# Technical design note

Project name	Himley Village, Bicester - Reserved Matters Application		
Design note title	Response to LLFA Comments		
Document reference	27141-HYD-XX-XX-TN-C-0002		
Author	R Austin		
Revision	P01		
Date	22 March 2023	Approved	<input type="checkbox"/>

The following Technical Note is to be read in response to LLFAs comments on the Reserved Matters application reference 23/00207/DISC regarding the surface water drainage strategy for the Proposed Himley Village development site.

TITLE  
MIDDLETON STONEY ROAD,  
MAIN SPINE ROAD JUNCTION.  
PROPOSED DRAINAGE  
SHEET 1

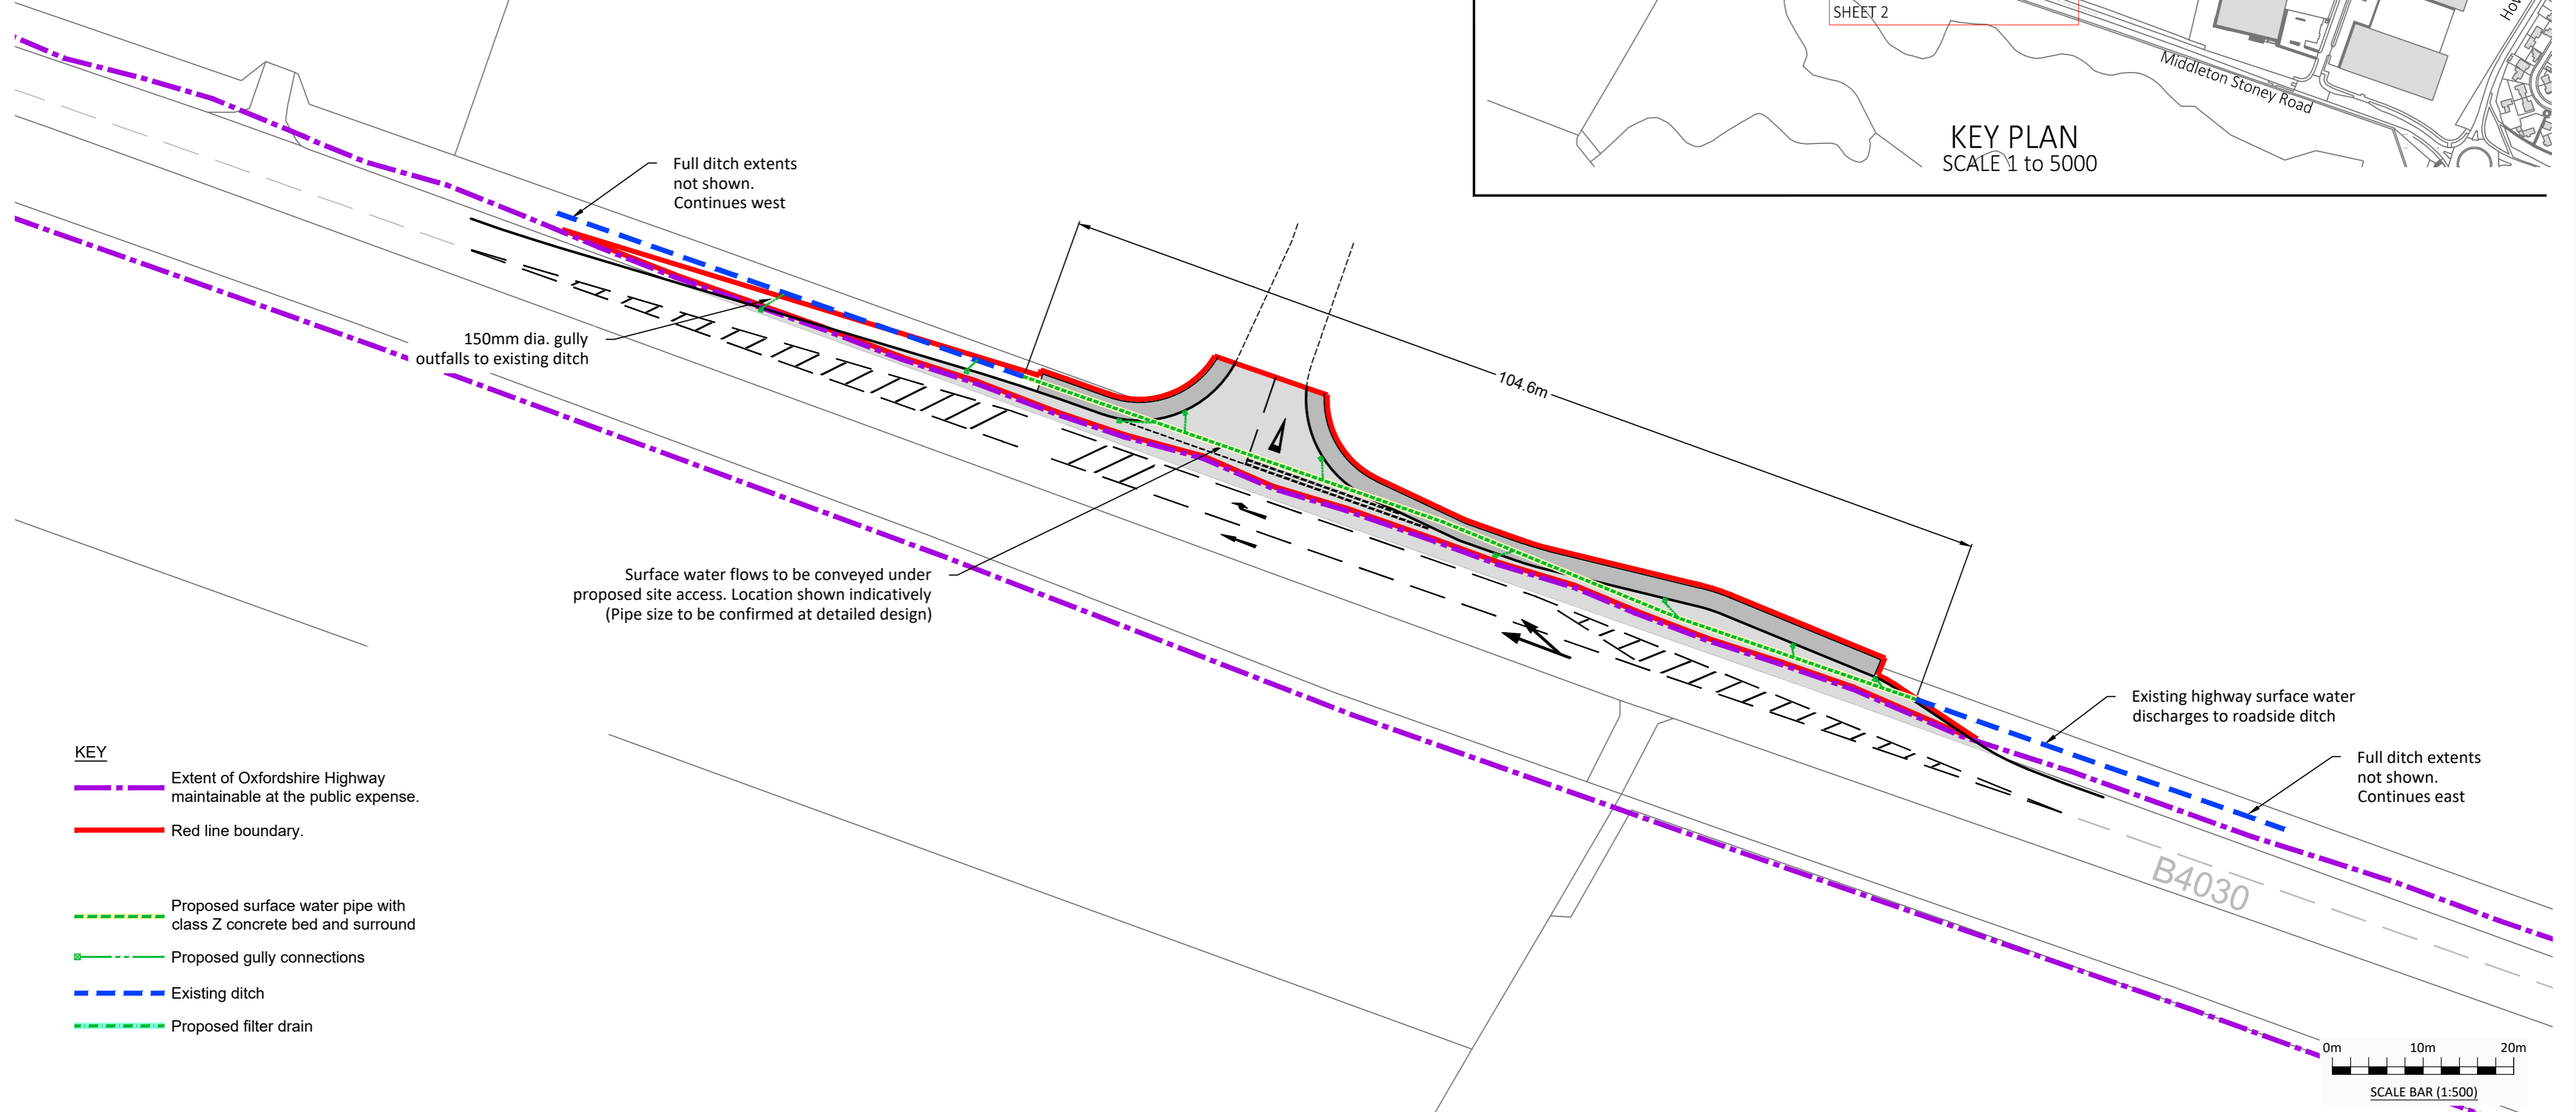
*Discharge rates not provided on a drainage plan for each outfall location. Drainage plan not provided.*

*Drainage plan is required and sizing of SuDS features needs to be shown clearly. Invert and cover levels of all drainage to be showing.*

*Detailed drainage layout with pipe numbers*

*Detailed drainage plan not provided to illustrate the SuDS features*

Drainage plans for each access are appended to this technical note, there is no specific network or "outfall" as such, each gully connect directly into the ditch adjacent (or culverted ditch if appropriate) and with each gully serving no more than 140m<sup>2</sup>, a 20mm/hr rainfall event would see outfall rates from each gully at a maximum of 0.77l/s.

Drainage plans for each access are appended to this technical note, there are no specific SuDS features in this application which is solely for 2x highway access points. The only drainage apparatus proposed are gulleys with no distinct cover or invert level.

Drainage plans for each access are appended to this technical not, there are no pipe numbers as there are no networks, the access locations are served only by individual gulley connections.

Drainage plans for each access are appended to this technical note, there are no specific SuDS features in this application which is solely for 2x highway access points, the ditches proposed for use are existing.
